July 10, 2014

Re: Comments on the 2014 Integrated Report

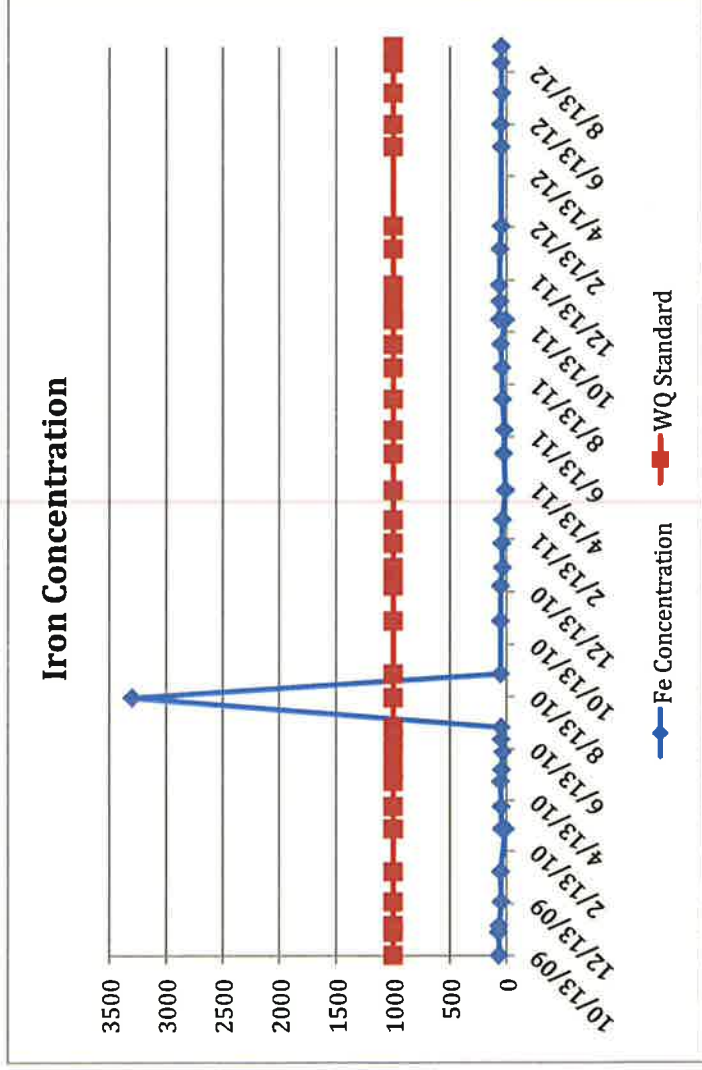
When a larger data set is present with greater than 10 total samples the use of one acute violation may still be simply an outlier and an error in data collection or sample analysis. The sample could be a real value, but the infrequency the acute violation occurs would make it practically impossible to determine a source for the high value. As can be seen from the following graph, there is only one exceedance in about 37 samples. This high number of samples with just one sample greater than 75 times the average of all other samples lends suspect to the one exceedance.

The above data is from monitoring location 4992480 – Mill Creek above the confluence with the Jordan River at the USGS Gage Station. Again, it is our opinion that such a single exceedance should not be a cause for listing on the 303(d) list.

## Chromium Concentration

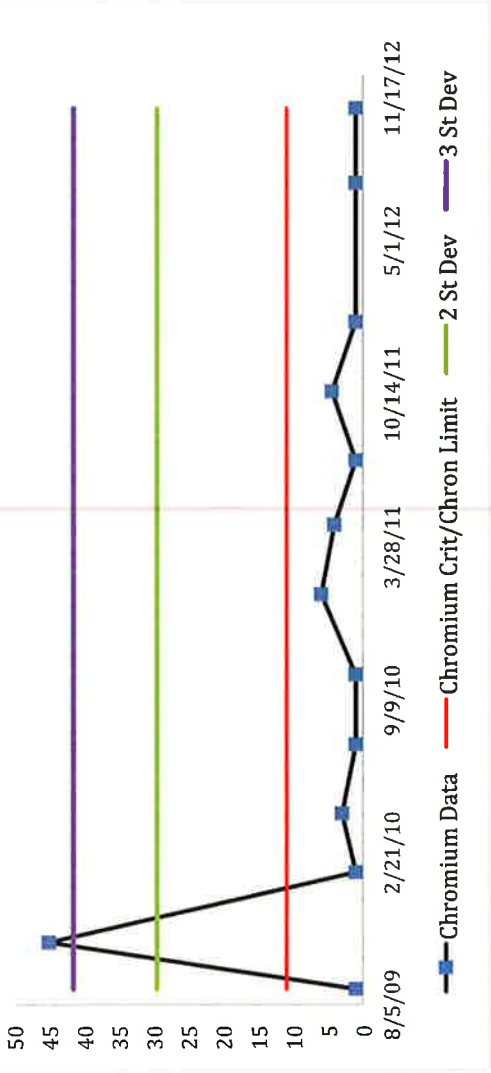
Confirming this opinion that a single exceedance is insufficient for listing, below is a graph from Monitoring Location ID 4990987 – North Canyon Creek in Legacy Nature Preserve. This data set has one significant exceedance that is inconsistent and much higher than all the other samples in the data set. This again confirms that 303(d) listing is inappropriate with outliers that are likely inaccurate. While we would rather see all such monitoring locations indicated as Category 1 waters as fully supporting for this pollutant at this location, we understand that it may be necessary to include them in Category 3 as lacking sufficient data.

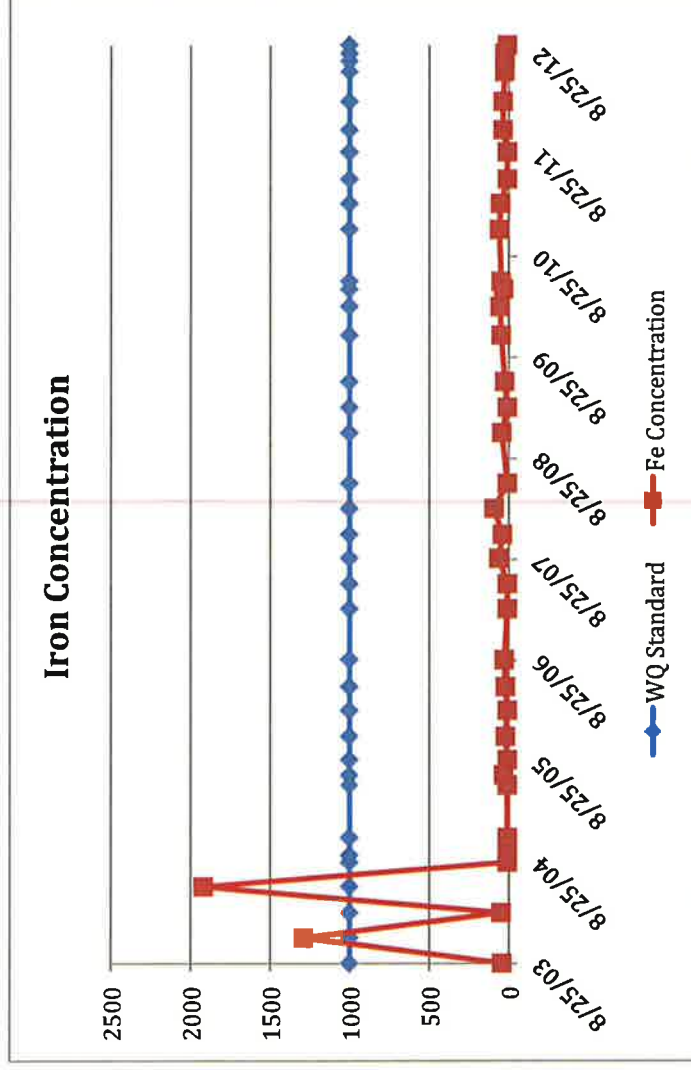
As can be seen, all of the above samples were collected on the same date. In addition, all of the samples were significantly higher than all other samples at their individual monitoring site. The samples above were the only samples above the criteria at each location. In this case either laboratory error occurred, the samples were reported in the wrong units, there was a continuous field sampling bias or there was a significant release of iron in each creek on the very same day. Besides the Columbus-Rexall Mine outfall, all of the other iron acute violations should probably be included in one of the Category 3 brackets. This conclusion is supported by the information from monitoring location ID 5994410 – Johnson Canyon. Below is a graph of the data from this location.

While two samples exceeded the criteria, the age of the two exceedances is such that to place it on the 303(d) list is inappropriate in our opinion. Again, this sample belongs in category 3 with insufficient data to make a determination.

1. At least two exceedances must occur before being placed on the 303(d) list. Single exceedances may be placed in Category 3 indicating insufficient data.
2. All iron listings, except the Columbus – Rexall Outfall, should be placed in Category 3 until an outlier analysis is done and the vast difference between the typical value and the outlier is explained or validated with additional sampling.

## Calcium and Total Hardness of Little Cottonwood Creek at the Influent to the Water Treatment Plant

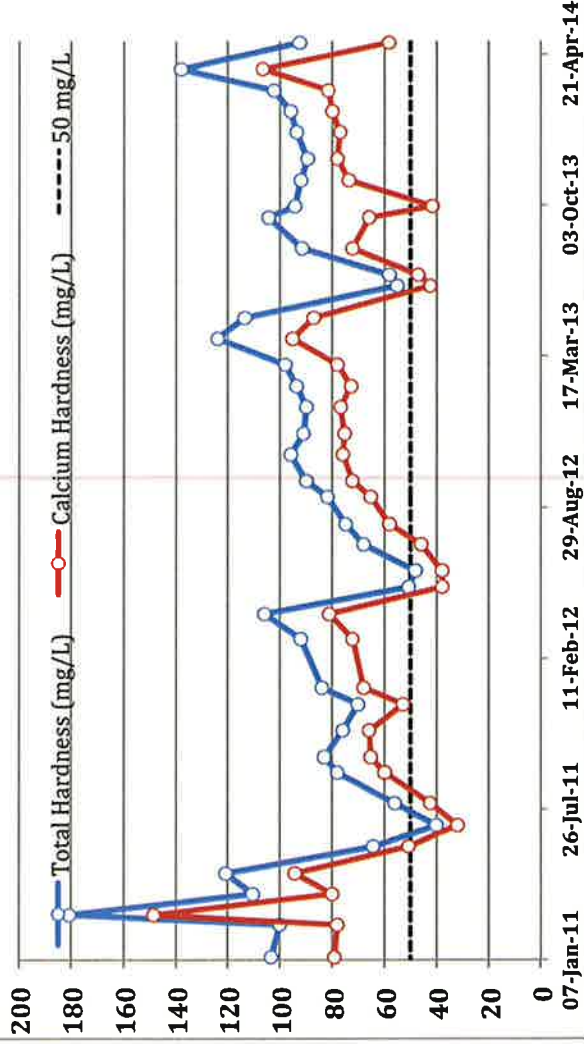
Hardness values decrease sharply during the runoff period. Then, after run off, hardness increases reaching a peak in the spring.

As can be seen, measured total hardness rarely falls below 50 ppm.
